## **NUCLEAR REGULATORY COMMISSION**

Title:                   Advisory Committee on Reactor Safeguards  
                              APR 1400 Subcommittee Meeting

Date:                  Tuesday, October 4, 2016

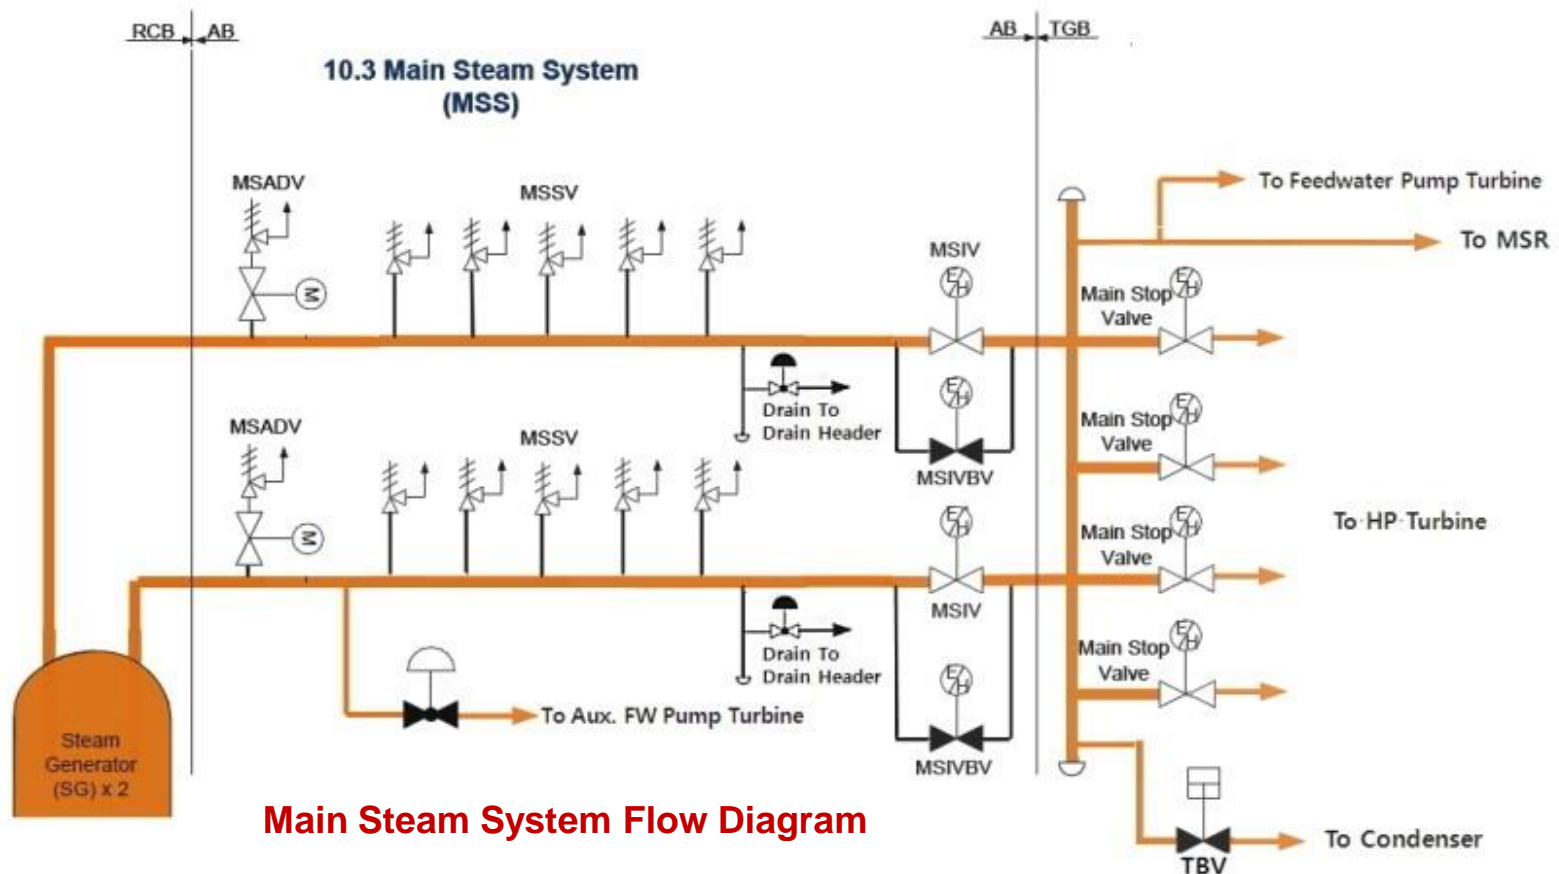
- **Description of Issue:** Address electrical and fluid flow paths, shared components, failure modes, and CCF vulnerabilities and also provide a description on reliable operation of hydraulic/air systems as associated with preventing turbine overspeed conditions. Clearly indicate what parts are shared. For clarity, the response should include schematic diagrams that show the control fluid flow paths, piping and valves being actuated (i.e., turbine stop, control, reheat stop, intercept, and extraction non-return valves).
- **Resolution:** As noted in response to the last two Open Items, more detail is being added to the functional requirements to address requirements for diversity, redundancy, etc. Other examples are:

Diversity – i. In conjunction with normal control and electrical overspeed trips, the purely mechanical overspeed trip does not depend on electric power (power is required to keep the mechanical trip solenoid valve energized to prevent manual trip). ii. TGCS & EOTS use diverse speed inputs, determine trip validity using different technology, have different set points, and actuate to drain control oil, to eliminate common cause failures from rendering trip functions inoperable. MOTS senses speed via physical repositioning of a weight, rather than sensing rotation rate.

Separation – Hydraulic control oil drain headers for MSVs and CVs and for ISVs and IVs are separate and separated on opposite sides of the turbines.

Figure 1

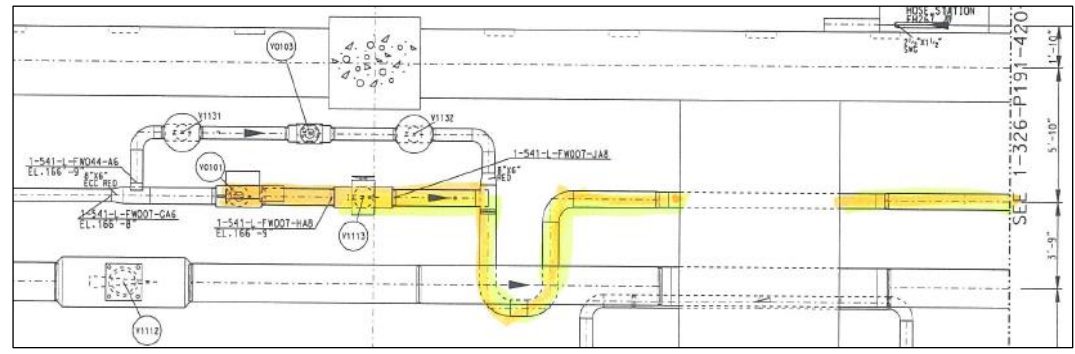
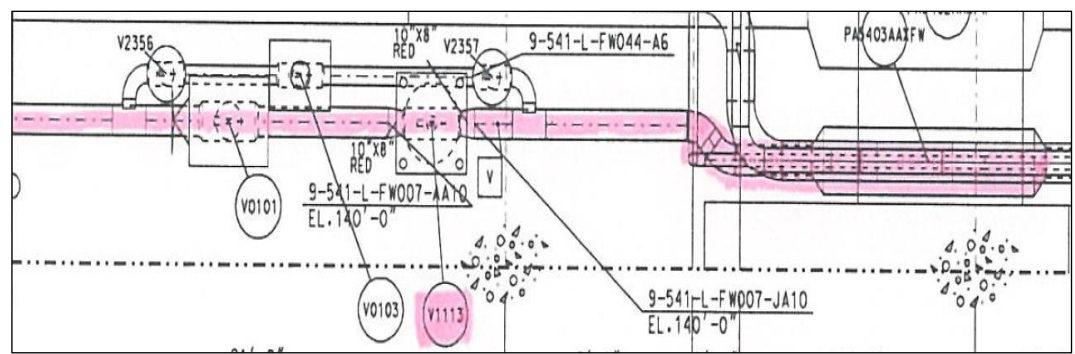
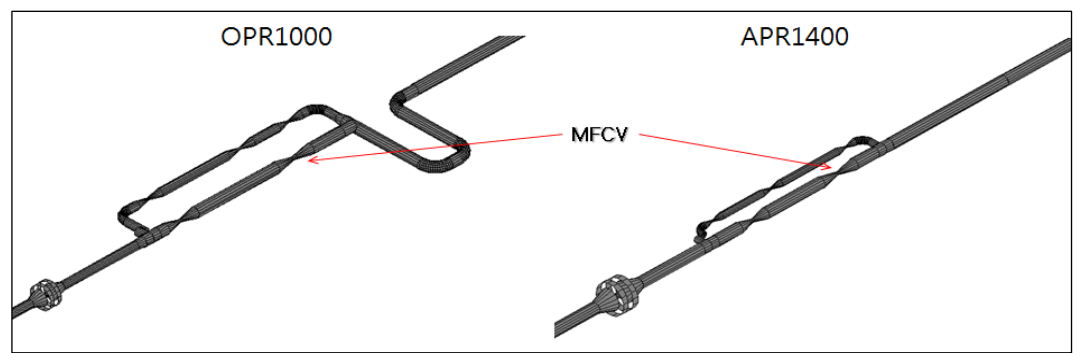
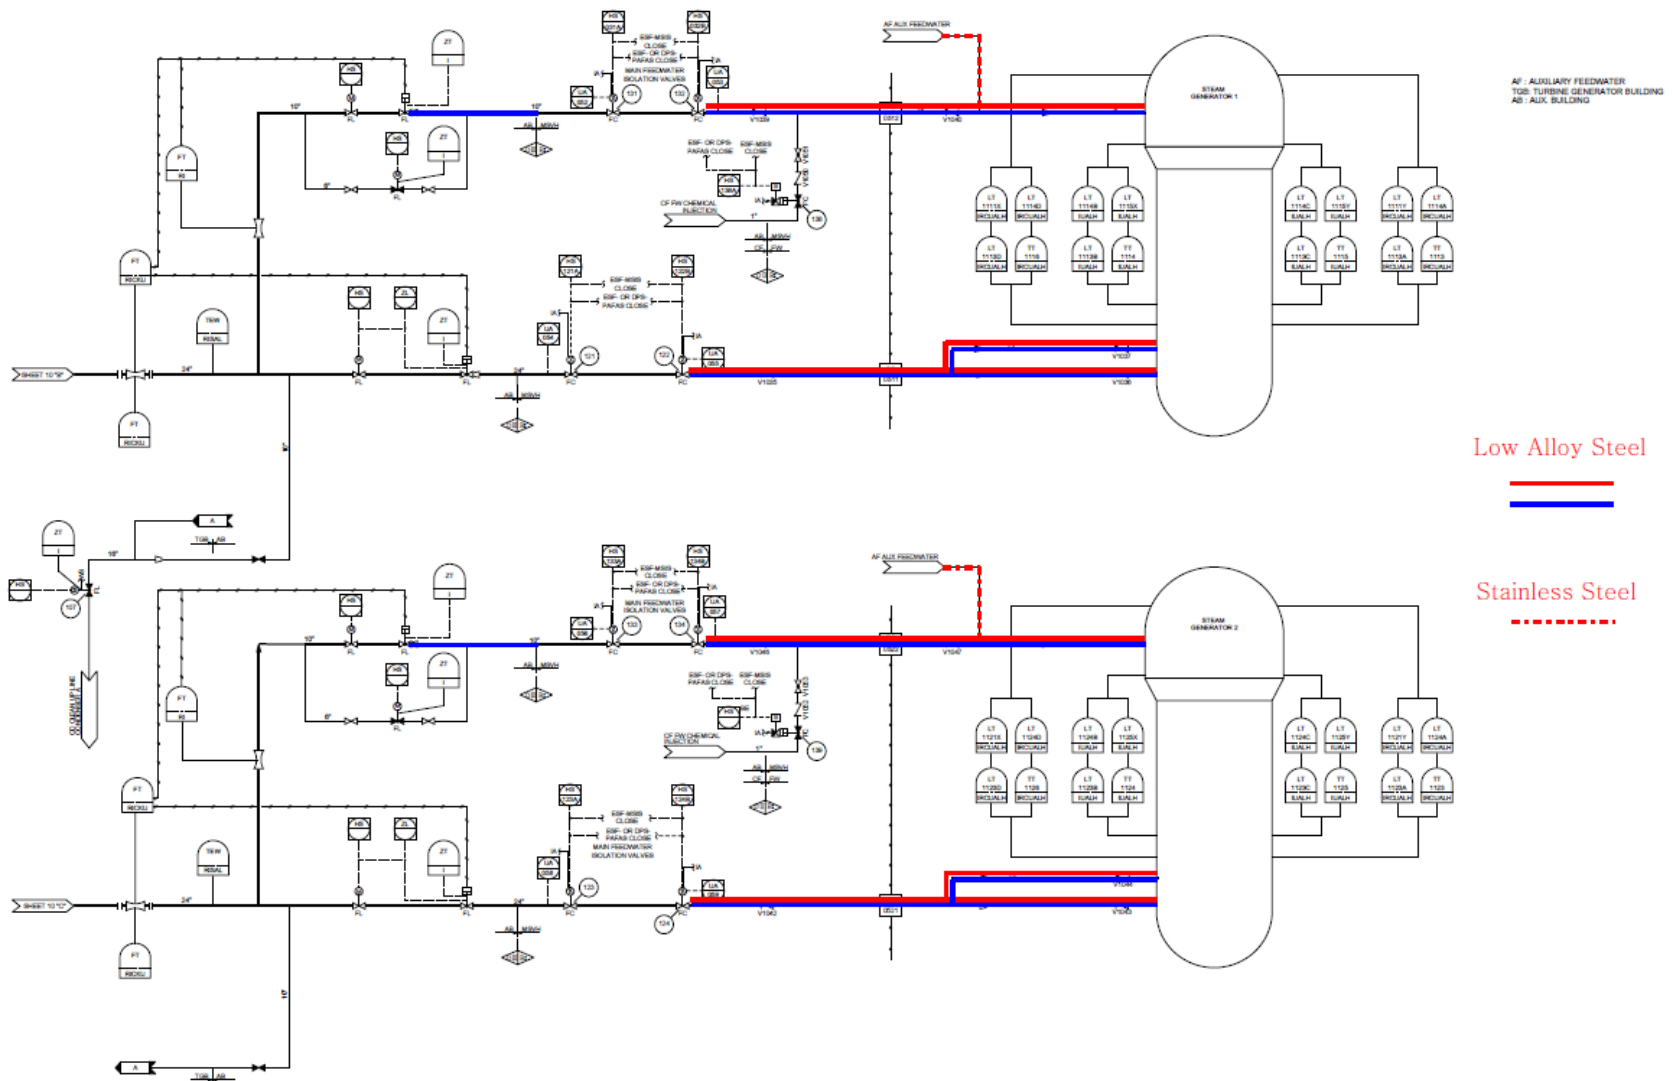
19 My answer is like this sentence. In  
20 OPR 1000 design, chrome-moly steel is utilized  
21 between the main feedwater control valve and the  
22 main steam air valve house, right, which contains  
23 sharp bending portions susceptible to flow  
24 accelerated corrosion, as shown in figure 1.

2 In the APR 1400 design, carbon steel is  
3 utilized between the main fuel control valve and  
4 the main steam valve house, right, which does not  
5 have sharp bending portions, as shown in figure 2.  
6 This slide shows figure 1, 2, 3. As you can see,  
7 this figure 1 in OPR 1000 design, there is a sharp  
8 bending portion, as you can see in this figure.  
9 So, the rule I raised here was installed. On the  
10 other hand, in APR 1400 design, there are no sharp  
11 bending portions. So, we have changed the material  
12 to carbon steel.

13 Figure 3 shows the three-dimensional  
14 configuration between OPR 1000 and APR 1400 design.  
15 This slide shows the material comparison between  
16 OPR 1000 and APR 1400. As you can see with this  
17 figure, these portions that were installed with  
18 roll that are still in post-design, OPR 1000 and  
19 APR 1400. On the other hand, this portion between  
20 the main feedwater control valve to the main steam  
21 valve house were installed with roll in just the  
22 OPR 1000 design.

- Open Item 10.3.6-3 (RAI No. 8649, Question 10.03.06-26, Date issued (07/26/16); KHNP responded (09/29/16)
  - **Description of Issue** : The staff noted a configuration of: chrome-molybdenum steel to carbon steel to chrome-molybdenum steel in the downcomer line. This configuration is more susceptible to FAC as discussed in NSAC-202L Revision 3.
  - **Resolution** :
    - a. In OPR1000 design, chrome-moly steel is utilized between MFCV and MSVH line which contains sharp bending portions susceptible to FAC as shown in Figure 1. In the APR1400 design, carbon steel is utilized between MFCV and MSVH line which does not have sharp bending portions as shown in Figure 2. The 3D piping layout is presented in Figure 3 in line of between MFCV and MSVH comparing OPR1000 and APR1400 design.

Figure 4

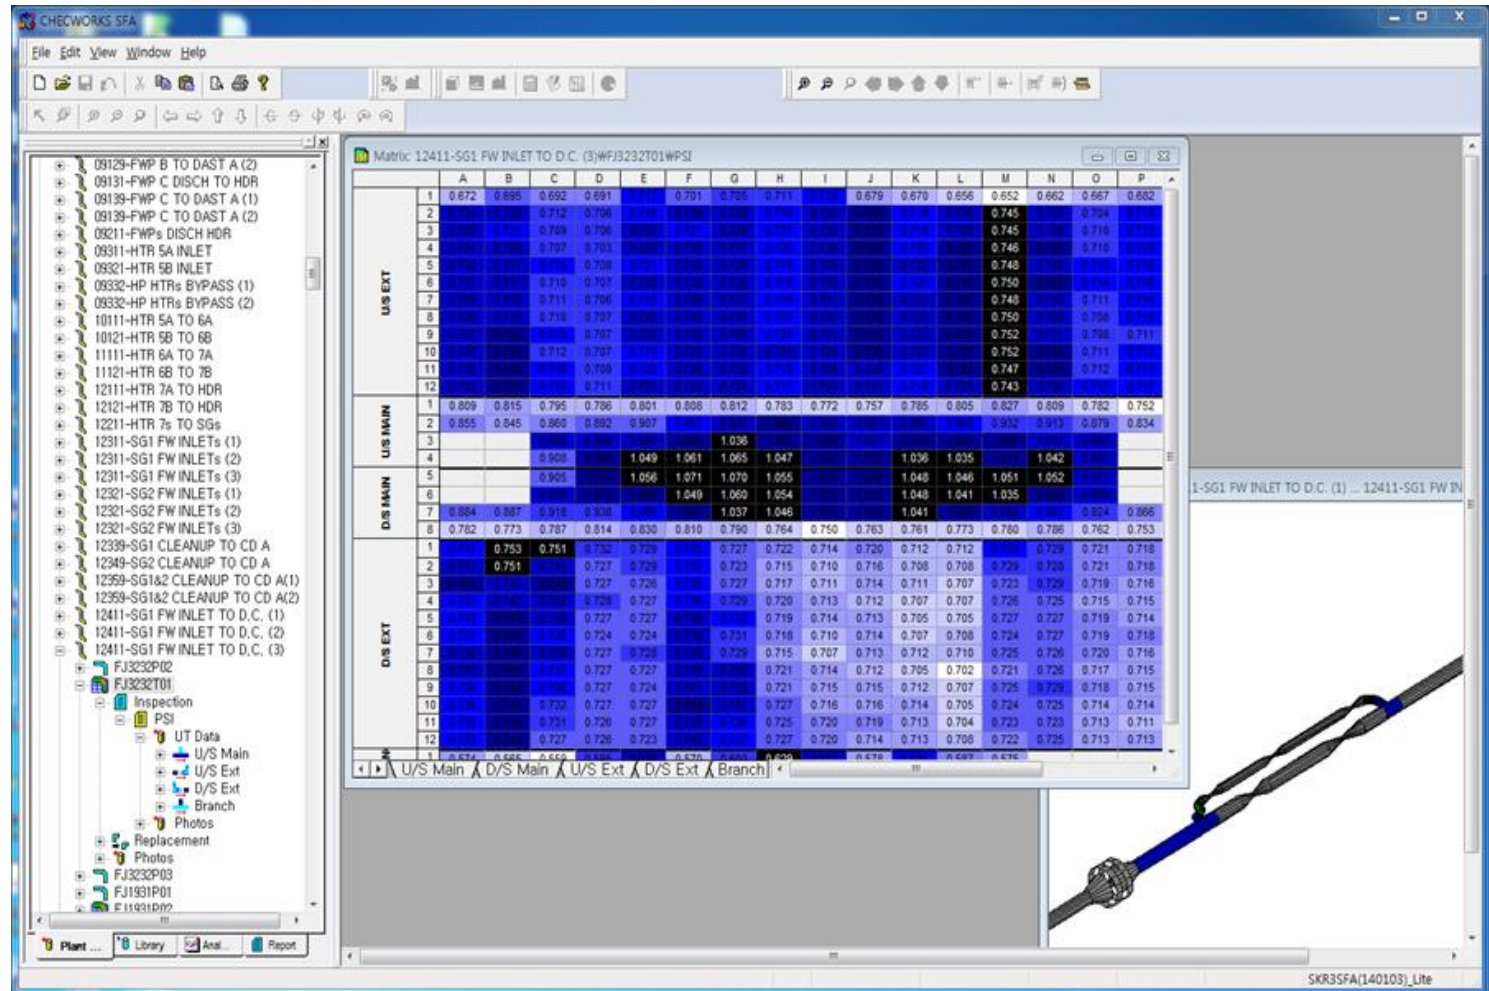
UT thickness inspection is performed to evaluate component wear beyond the toe of the weld. Initial wall thickness is taken in components placed downstream of the MFCV and will be inspected periodically during plant operation. Figure 4 shows the UT inspection data implanted to CHECWORKS which has been taken prior to the pre-operation.

- 10.4.8 Steam Generator Blowdown System – Open Item (1/1)

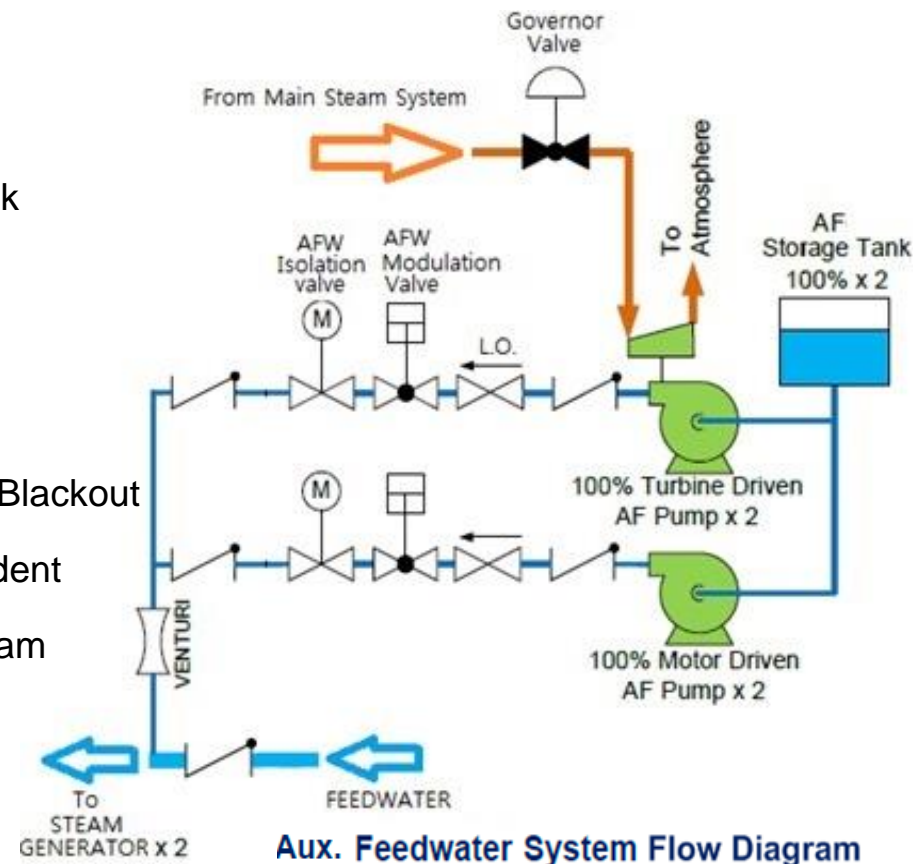
- Open Item 10.4.8-1 (RAI No. 8596, Question 10.04.08-6), Date issued (5/4/16); KHNP responded (8/8/16)
  - **Description of Issue** : Address the missing actuation signals (High Radiation Actuation Signal(HRAS) and Blowdown Flash Tank High-High Level Actuation Signal (BFTHHLAS) in DCD Figure 2.7.1.8-1 and to provide additional detail in DCD chapter 7 for consistency and clarity.
  - **Resolution** : Indicated the actuation signals (HRAS and BFTHHLAS) in DCD Figure 2.7.1.8-1 and provided the detailed description in DCD chapter 7 subsection 7.3.1.9.

- ♦ Revise Tier 1 Figure 2.7.1.8-1 to identify two additional control signals that activate CIVs in the SGBS. The applicant had proposed adding these control signals to the corresponding Tier 1 table but not to the figure. The two signals are:
  - High Radiation Activation Signal (HRAS)
  - Blowdown Flash Tank High-High Level Actuation Signal (BFTHHLAS)
- ♦ Provide a description in DCD Chapter 7 of the specific signals that activate the CIVs rather than a general description of instrumentation and control signals.

17 MR. J.W. CHOI: Yes. Our answer is  
18 like this: indicate the actuation signal HRAS and  
19 BFTHHLAS in DCD figure 2.7.1.8-1 and provide the  
20 detailed description in DCD Chapter 7, Subsection  
21 7.3.1.9.

## Section 10.4.10 – Auxiliary Steam System

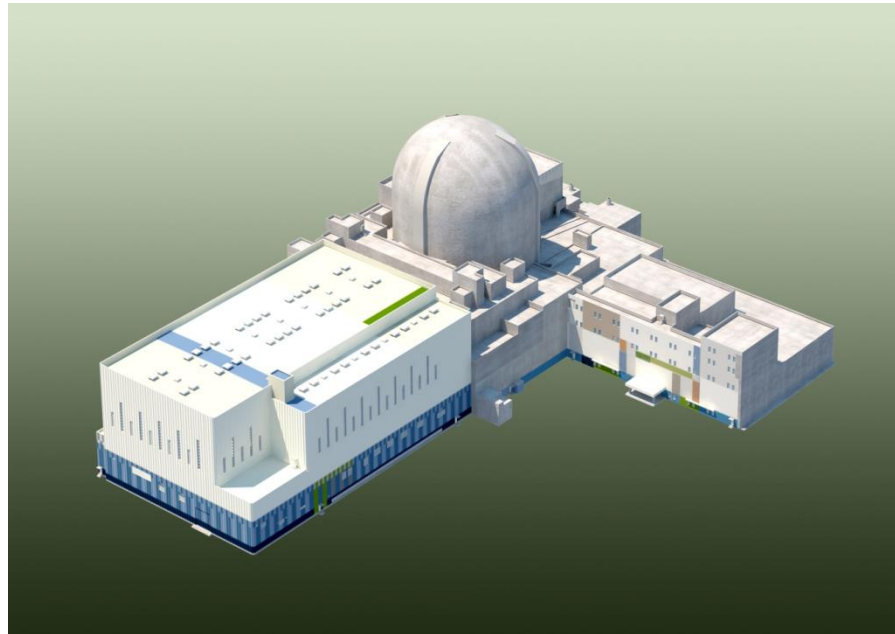
10 The second description of the issue is  
11 like this. The staff requests to the applicant to  
12 clarify the actual seismic and quality group  
13 classifications of the auxiliary steam system  
14 components and piping within the reactor  
15 containment building. The applicant is requested  
16 to modify the DCD figure 10.4.10-1 and table 3.2-1  
17 to clearly depict a consistent design.

- **Description of Issue** : Requests the applicant to clarify the actual seismic and quality group classifications of the auxiliary steam system components and piping within the reactor containment building. The applicant is requested to modify the DCD Figure 10.4.10-1 and Table 3.2-1 to clearly depict a consistent design
- **Resolution** : Containment isolation valves and associated piping are seismic category I and quality group B. The piping and valves downstream of the containment isolation valve within the reactor containment building are non-safety related, seismic category II and quality group D.
